Improved visibility alterations

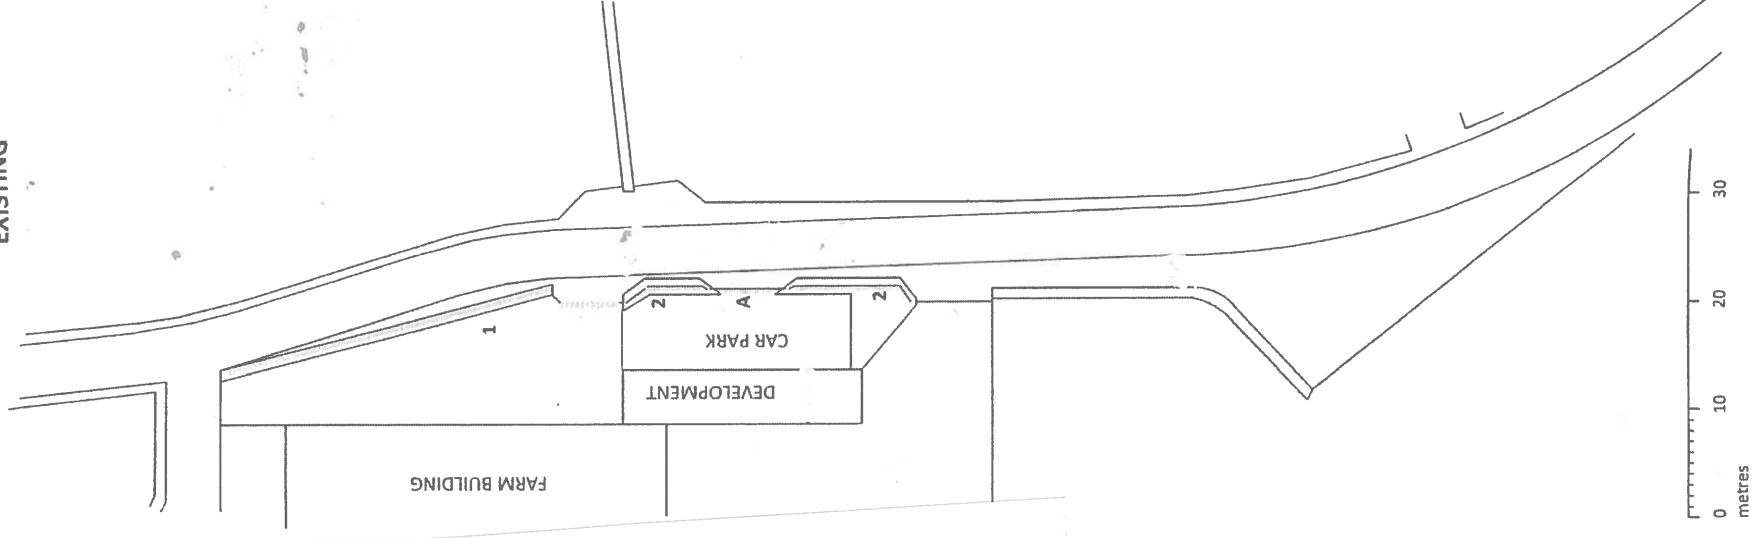
1. Hedge has been realigned as per planning ref: P/2008/0265
2. The top rail and gate will be removed to ensure the height will not exceed 0.85m (it is presently 1.1m)

The above measures increase the visibility splay beyond the required splay of 2.4 x 56m in both directions.
